TO: Planning Commission **Agenda of:** June 25, 2009

RE: DR00-0011/76 Gas Station & Circle K Mini Mart

CORRECTIONS TO THE FINAL EIR

November 4, 2008

Figure 2.0-1
 RV Turn Radius Entering From South Shingle Springs Road

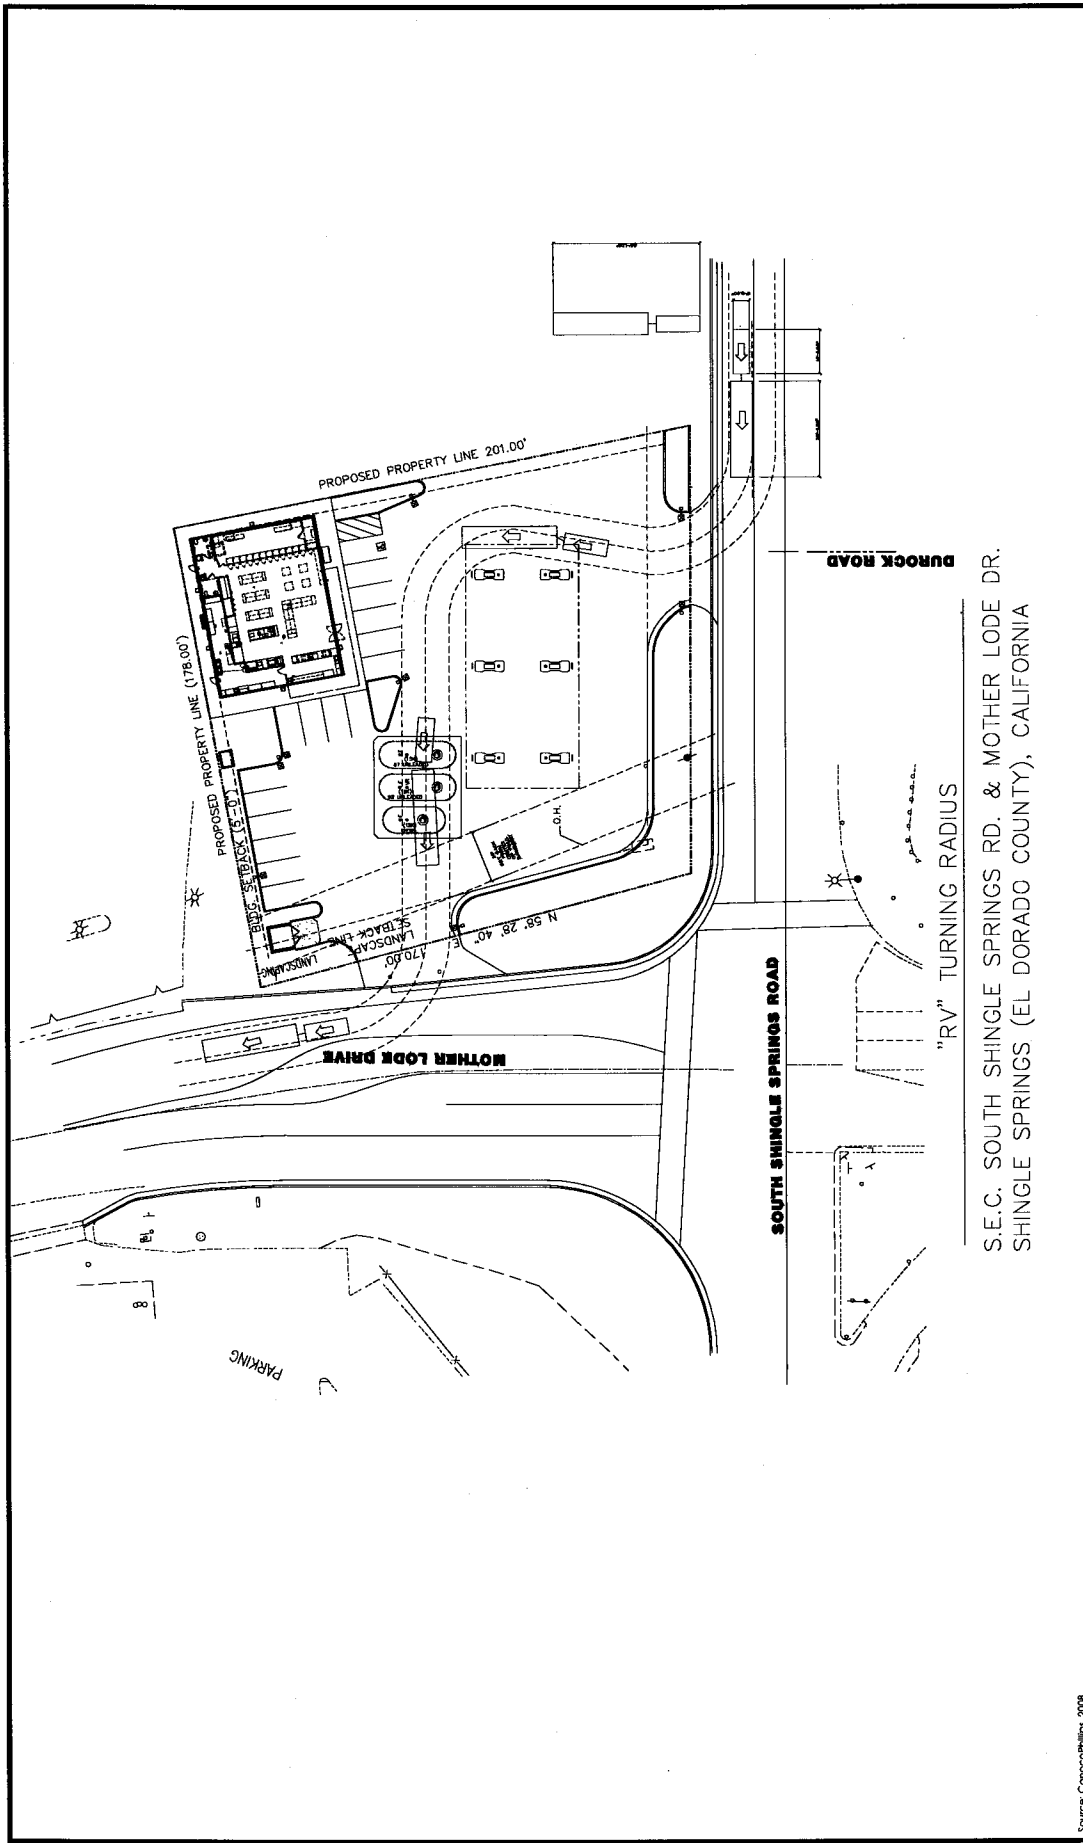
Dan Smith Letter Page 7: “. . . the FEIR response cites FEIR exhibits **Figures 2.0-1 2.0-2 and 2.0-3**. However, these critical pieces of evidence are nowhere to be seen in the FEIR as circulated. Because of the missing Figures 2.0-1 2.0-2 and 2.0-3, the FEIR is deficient as an information document and cannot be certified.”

The response, citing use of an updated site plan and a different source of turning templates (ones that we acknowledge are also authoritative) than those relied on in the comments, claims that the site is fully navigable by the most critical vehicle combination to visit the site. In attempting to demonstrate its conclusion, the FEIR response cites FEIR exhibits **Figures 2.0-1 2.0-2 and 2.0-3**. However, these critical pieces of evidence are nowhere to be seen in the FEIR as circulated. Because of the missing Figures 2.0-1 2.0-2 and 2.0-3, the FEIR is deficient as an information document and cannot be certified.

The absence of missing Figures 2.0-1, 2.0-2 and 2.0-3 makes it impossible to fully evaluate the response. However, we note that in many instances the response a) admits the constraint we identify but claim the constraint is commonplace at some gas stations, b) admits the constraint but claims it can be overcome by undesirable multi-part maneuvers, or c) admits the constraints exist but claims that drivers will overcome it by using an easier to access or egress fueling position. In one instance, the response indicates that the constraint can be overcome by the obviously hazardous maneuver of backing into the driveway. In another instance, the response indicates that the constraint can be overcome by making a tortuous U-turn across the south portion of the site to exit via the driveway of entry – a maneuver that would freeze most maneuvers on or entering the southern portion of the site while it was being completed. While the response in some way speaks to every constraint identified in the comments, it does not address the cumulative condition that emerges from these constraints. That

- b. After page 2.0-120, **Figures 2.0-1, 2.0-2, 2.0-3 and 2.0-4** are added to the Final EIR.
